Decision Document

Environmental Protection Act 1986, Part V

Works Approval: **W5830/2015/1**

Premises address: Allawuna Farm Landfill
 2556 Great Southern Highway
 ST RONANS WA 6302
 Being Part of Lot 4869 on Plan 224502 as depicted in Appendix C and
 defined between the following Global Positioning System positions:

Figure A3.1: Proposed Landfill Liner Design (Source: Golder Report, Appendix B)

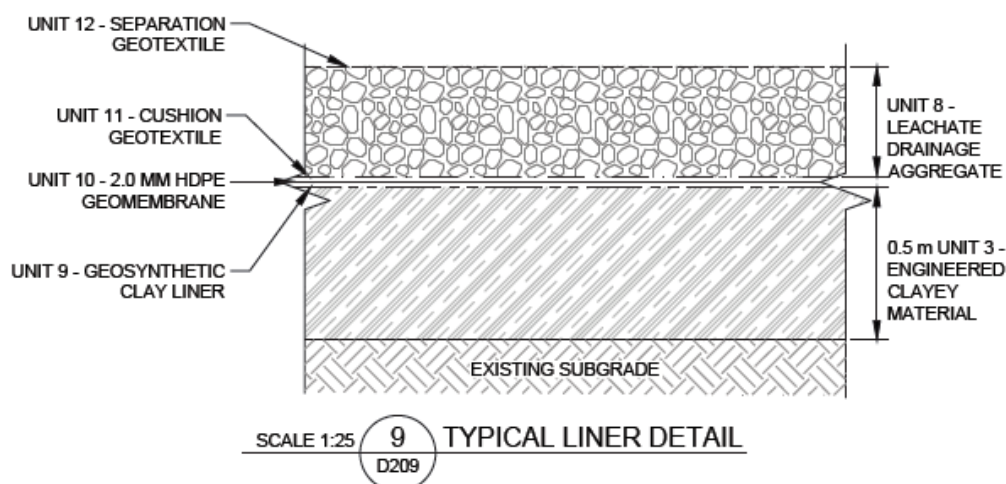
An assessment of the proposed liner design provided in the Golder Report has been undertaken and the CEO's delegate considers it appropriate. The following summarises the main components as depicted in Figure A3.1:

Condition 1.2.2 in the Works Approval requires that there is at least 2m separation to groundwater below waste at the base of the landfill. (The designed base of the landfill, as illustrated in Figures D7 and D8 of Appendix D (Figures D207 and D208 of the Golder Report), includes a minimum 2.5m separation from the base of waste to the highest predicted groundwater level (including groundwater levels which are indicative of an unconfined water table and those indicative of a semi-confined potentiometric head).

Figure 1 Summary of municipal solid waste strength data (based upon Singh and Murphy, 1990, source ref.1)

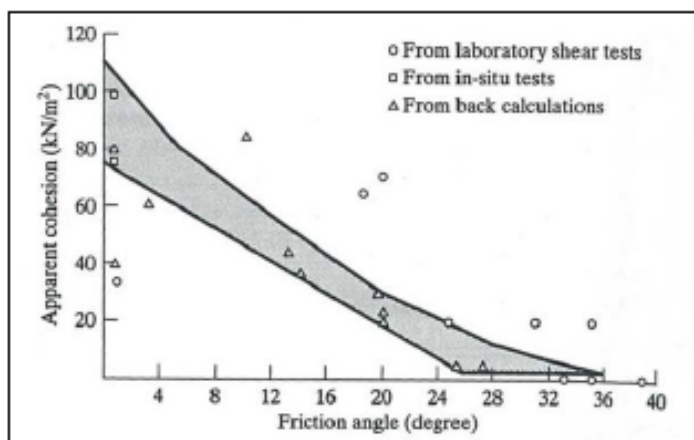
The strength parameters attributed to the waste as presented within Table 5 of Appendix F ($\phi' = 25^\circ$ and $c' = 5\text{kPa}$) are considered lower bound based on published values as shown in Figure 1.

It is considered that increasing the effective cohesion of the waste material may result in the minimum FoS for waste stability under MCE conditions (Appendix F output Figure B8) increasing to from 0.95 above 1.0.
